DOE/ER-0463P

**Report of the
DOE Office of Energy Research
Review Committee
on the
Site-Specific Conceptual Design
of the
Superconducting Super Collider**

September 1990

**U.S. Department of Energy
Office of Energy Research
Office of Superconducting Super Collider**

Figure 7.1. SSC Project Summary Schedule: the master schedule developed by the SSCL.

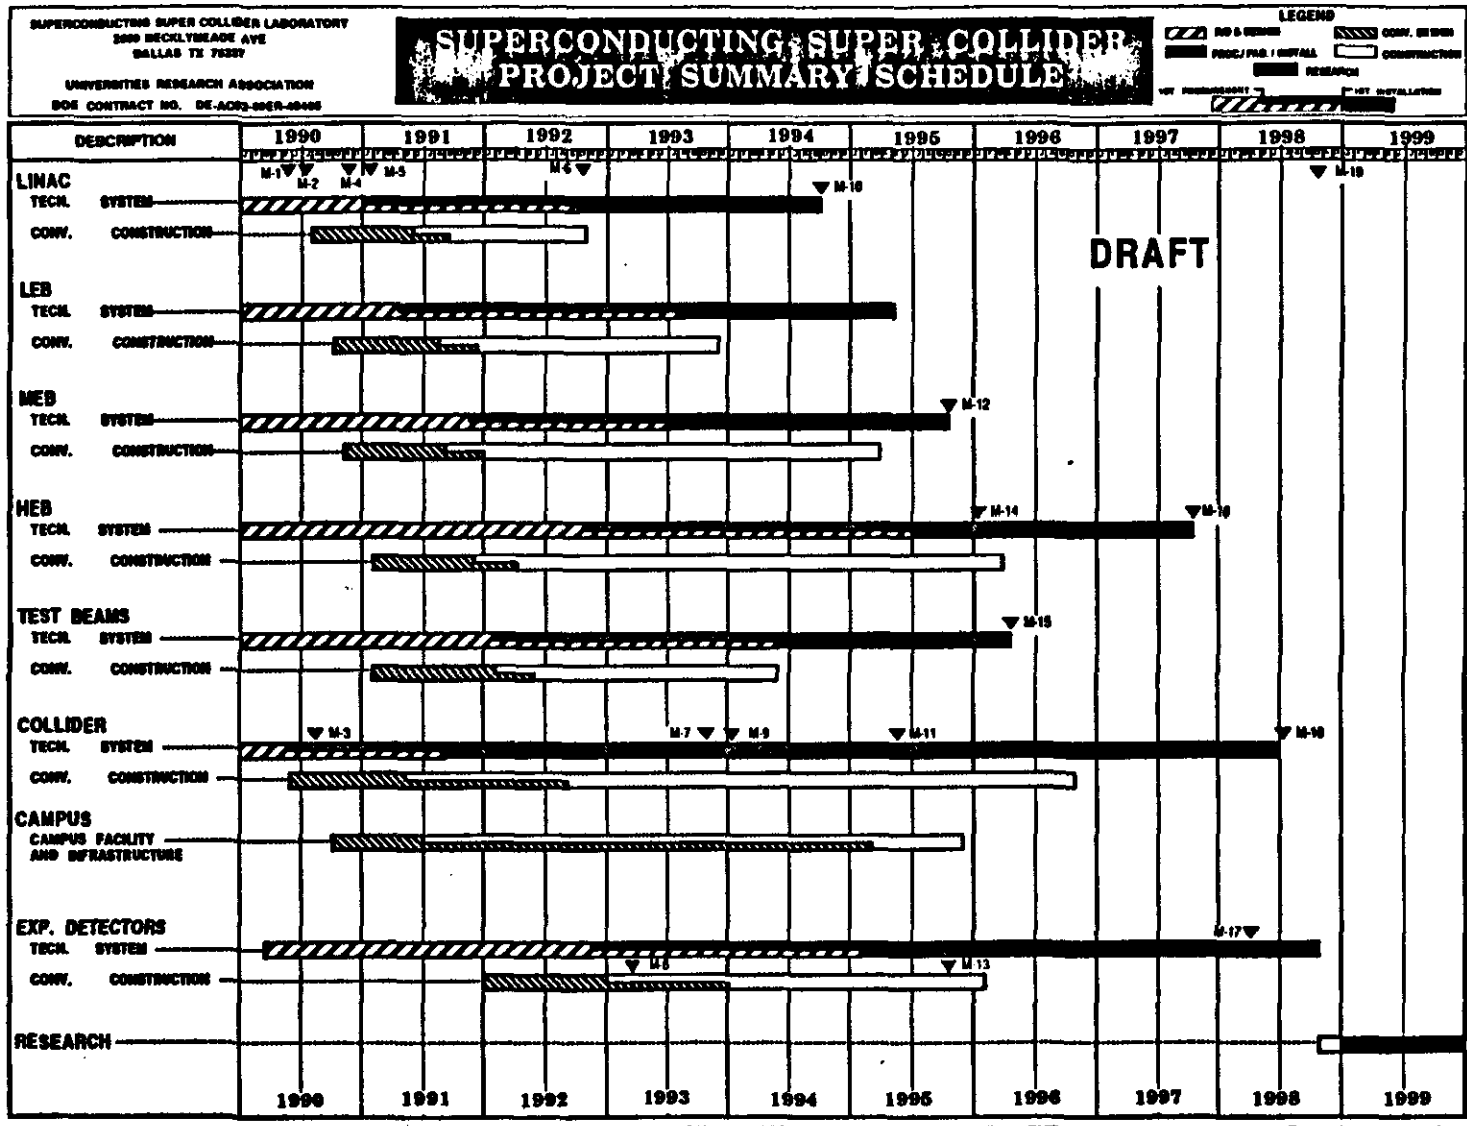
The proposed cost-optimized construction project schedule leading to completion in late 1998 is considered by the committee to be possible, although it is very aggressive and, therefore, carries considerable schedule risk. The committee points out that this schedule results in a funding profile developed by the SSCL that rises rapidly to over \$1.25 billion per year for FY 1992 through FY 1995. This schedule implicitly assumes that the required level and quality of technical staff is put in place quickly, that the R&D program proceeds on a success-oriented, fast-track schedule, and that the development of the currently undeveloped SSC site and of the associated support infrastructure proceeds rapidly. Thus, the SSCL estimate of the TPC probably represents a lower bound; the potential for significant increases in as-spent dollars is high if the schedule and funding profile proposed by SSCL are not achieved. The testing of industrially assembled superconducting magnets in the E1 complex in September 1992 represents a critical milestone which should be carefully monitored in order to gauge the project's early progress.

The SCDR master schedule developed by the SSCL, presented in Fig. 7.1, was developed to indicate an overall logic for integration of R&D, design, construction and commissioning activities leading to completion of the project in late 1998. Funding profiles were also developed by SSCL for a baseline case (Fig. 7.2) and for an alternate case (Fig. 7.3), which takes into account delays in the construction of the tunnel until after the ability to produce collider dipole magnets is proven. The SCDR schedule has been manpower loaded to reflect the overall manpower plan for the SSCL (Fig. 7.4). The baseline schedule and resulting funding profile assume that an aggressive ramp-up of resources and an obligational authority of between \$1.25 billion and \$1.39 billion will be provided between FY 1992 and FY 1995. The schedule also assumes that the very aggressive pace of project activities can be planned for and maintained throughout this period.

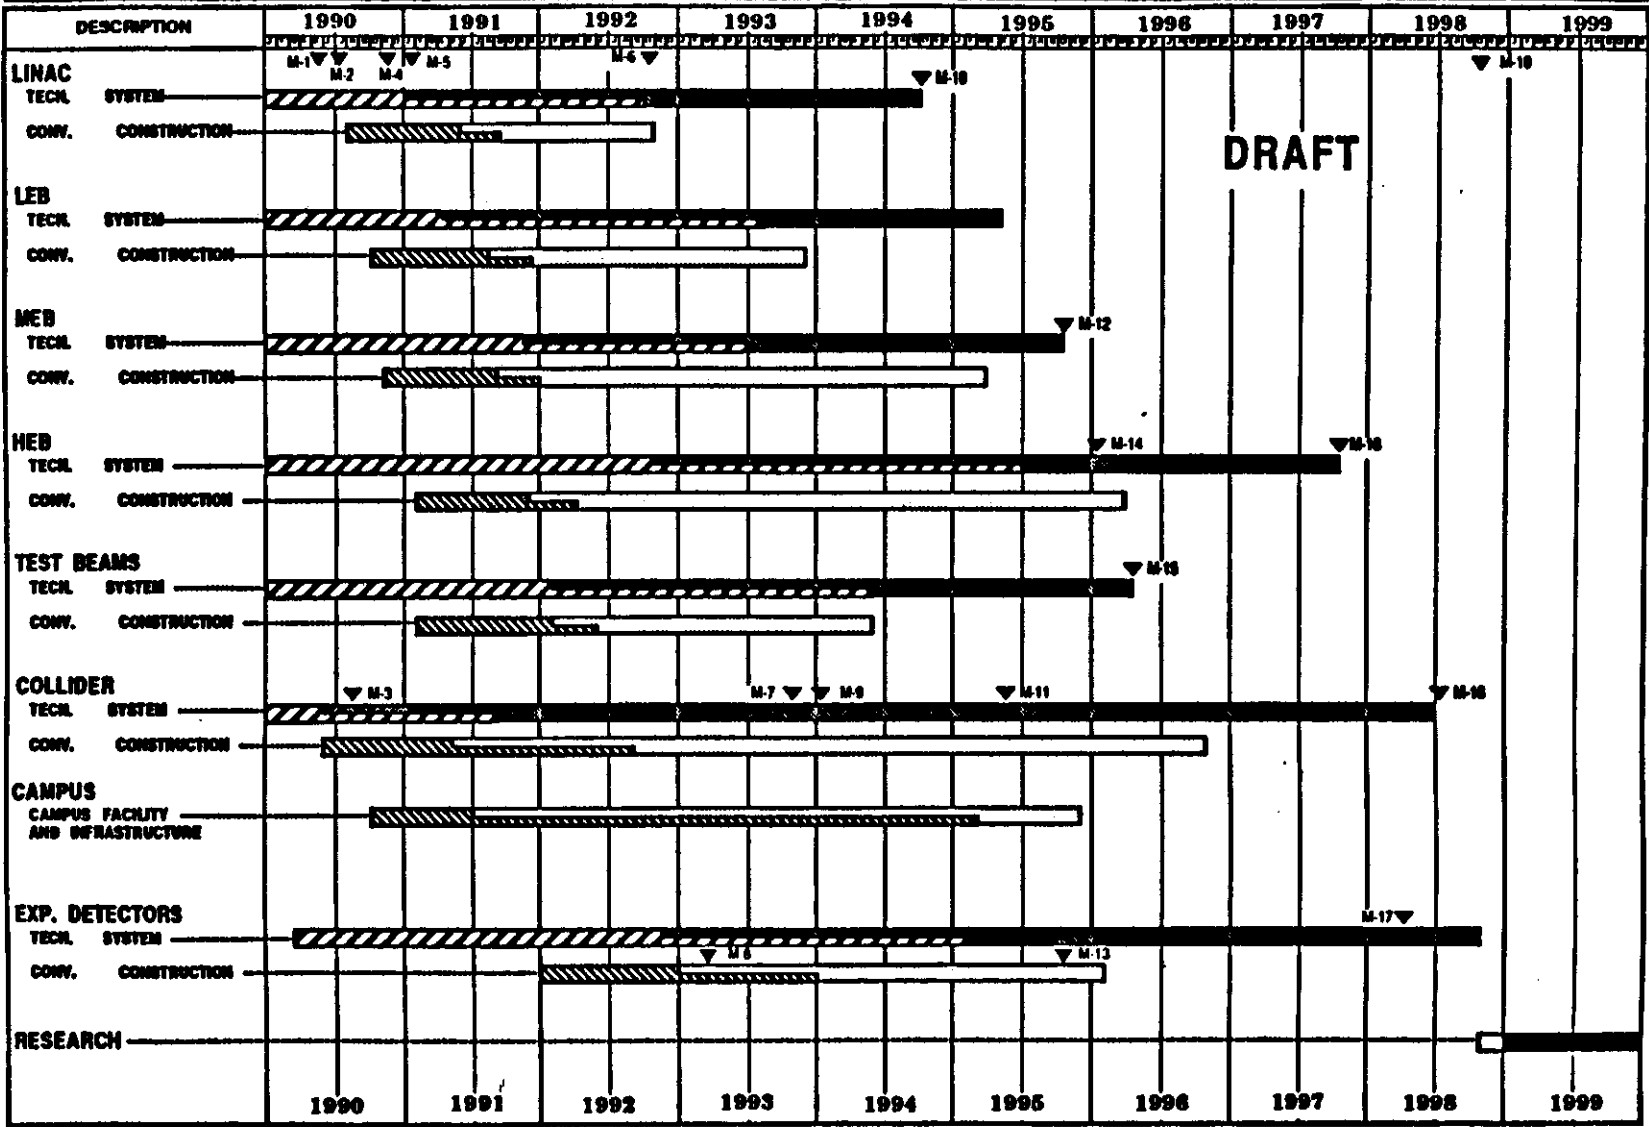
Fig. 10.9.7-1 shows the proposed project summary schedule for the construction of the SSC. The SSCL has developed a schedule with supporting logic that justifies a nine-year program. The schedule incorporates the R&D program, manpower loading, and contract projection in a consistent manner. The schedule is very aggressive and depends on early initiation and completion of critical milestones. It has several activities (magnets, tunneling, injector) near the critical path. The scheduling database contains both the R&D

Fig. 10.9.7-2

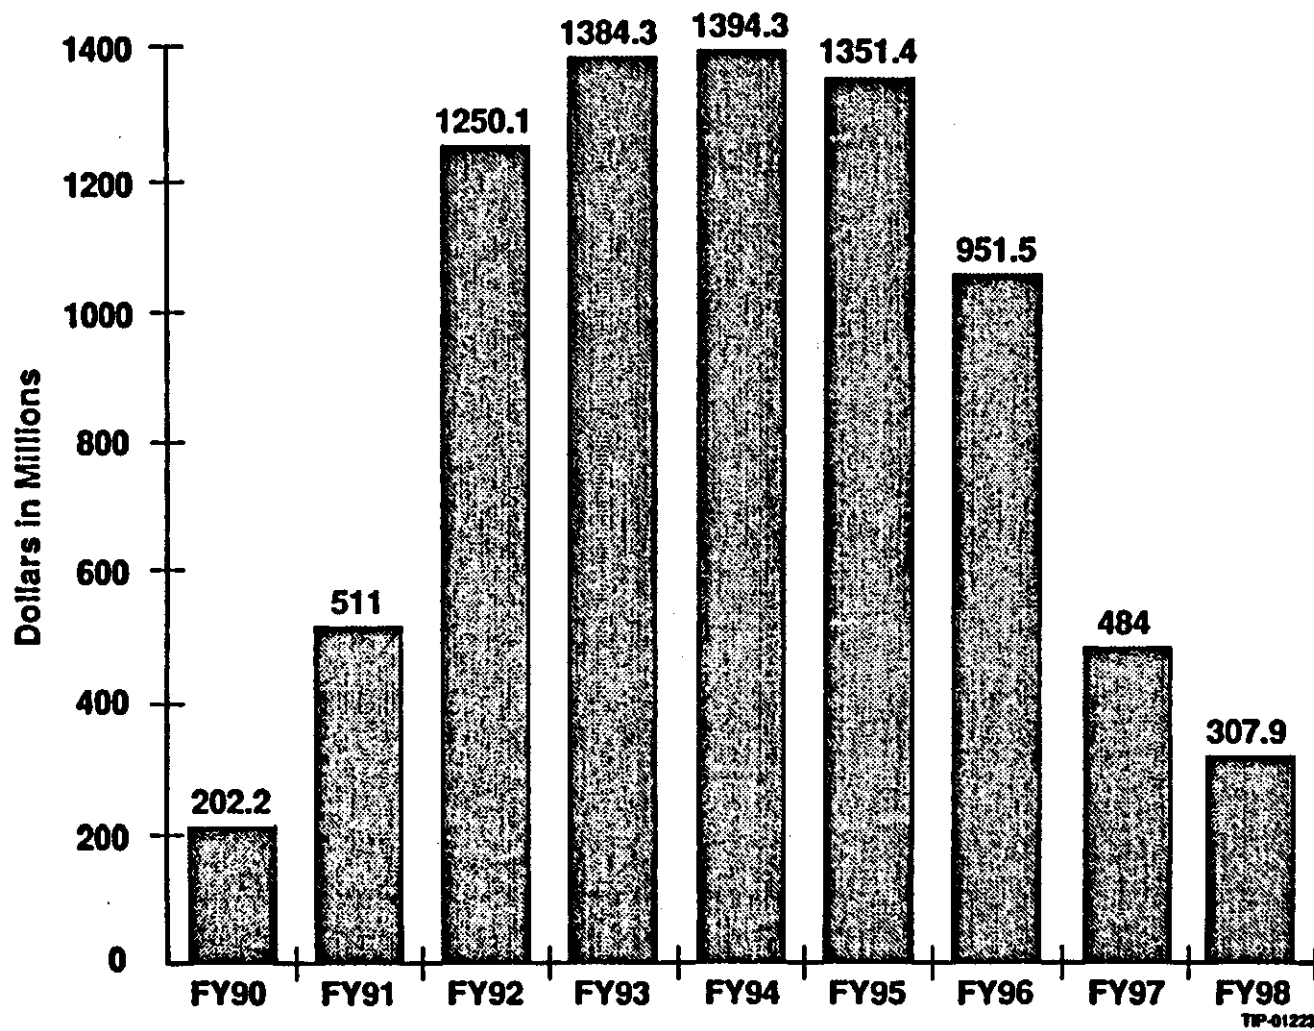
The proposed project funding profile (Fig. 10.9.7-2) shows an accelerated ramp-up in early project stages, and approximately equal large expenditures for a 4-year period. Thus a small slip in the aggressive project schedule could cause a significant change in the funding profile. The SSCL must constantly monitor and be aware of the effect of changes causing individual activity slippages and impacting the overall project schedule. The SSC scheduling system has the ability to assess changes that could arise which may impact the project schedule and funding profiles.
